STAFF REPORT

REGIONAL CENTER HEARING EXAMINER - HIGH IMPACT CASE

Case Number	2026-REG-006
Address (approx.)	219 Koehne Street, 1437 – 1533 (odd) Saulcy Street, and 1422 – 1528 (even) Astor Street
Location	Center Township, Council District #18
Petitioner	Union Holdings III, LLC, by Misha Rabinowitch
Zoning	D-8 (RC)
Request	Regional Center Approval to provide for demolition of existing dwellings and accessory structures and for construction of a multi-family residential development, consisting of approximately 241 units, an integrated parking garage with 258 spaces, and resident amenities, including a community room, a playground, dog park, and grilling area.

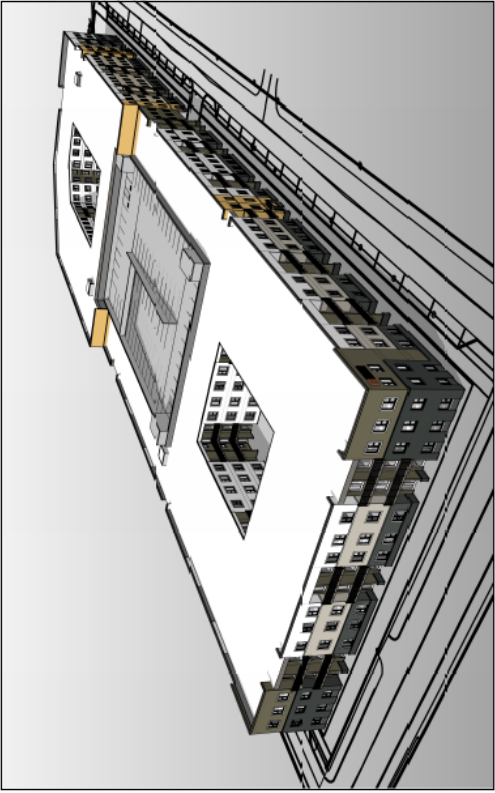
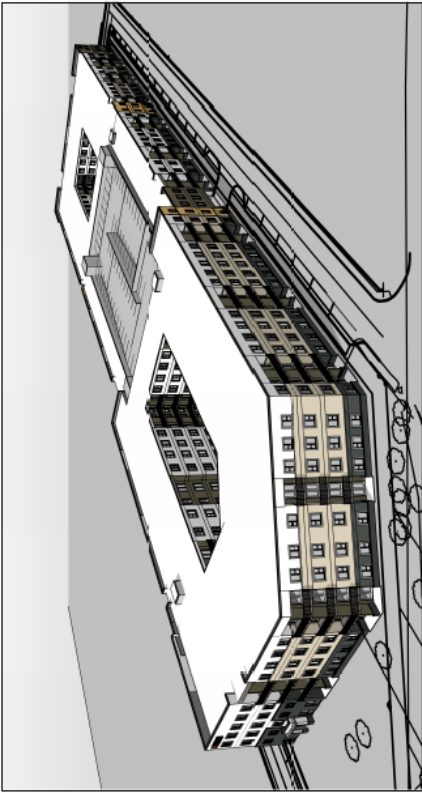
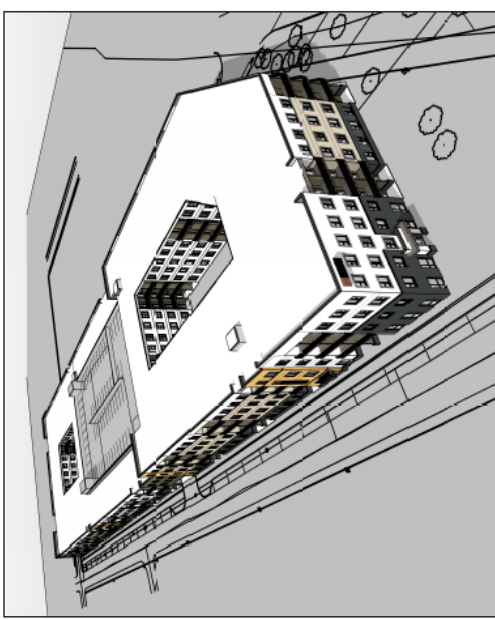
2. The building materials is primarily made of fiber cement, a man-made material. Staff requested additional natural building material. Subsequent revised elevations note added areas of brick on the façade. Guideline CA 2.2.1 applies.

Building materials would be primarily fiber cement with a brick base, and larger sections of brick on the west façade that wraps around the building corners and at the first and second levels on south portion of the east façade and wraps around the corner.
